MEMORANDUM

TO: County Council

FROM: Marlene L. Michaelson, Senior Legislative Analyst
Glenn Orlin, Deputy Staff Director

SUBJECT: Germantown Sector Plan

Tax Map showing:

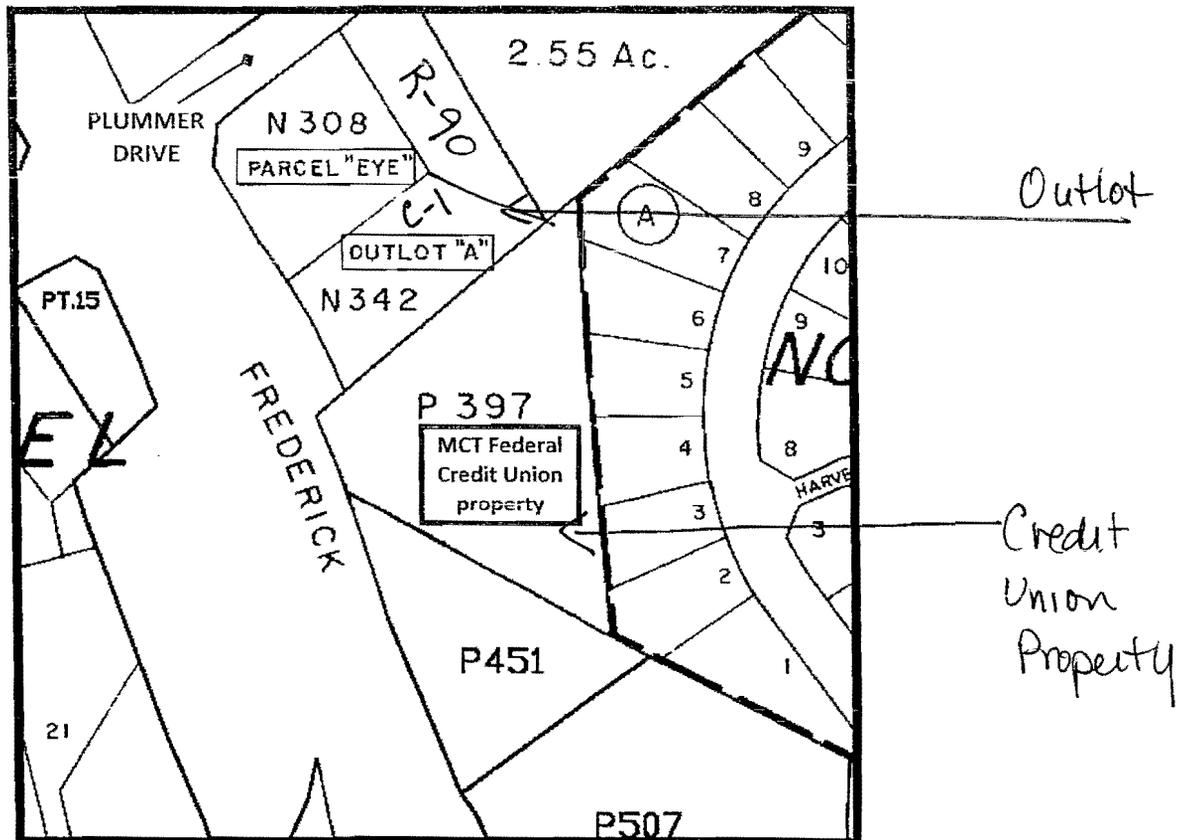
Testimony: The MCT Federal Credit Union supports the change in zoning from R-90 to C-1 but requests that adjacent outlot A, which is currently split zoned C-1 and R-90 (see © 17) be zoned entirely C-1 to provide access for the Credit Union to Plummer Drive, since they anticipate that the State Highway Administration will want to minimize access points along MD-355.

Staff Comments: Although this property is recommended for a change in zoning from R-90 to C-1, it is not discussed at all in the Sector Plan. The zoning change will enable the MCT Federal Credit Union to build a branch at this location. Absent objection from the property (which Staff has no reason to believe is likely), Staff supports the requested change.
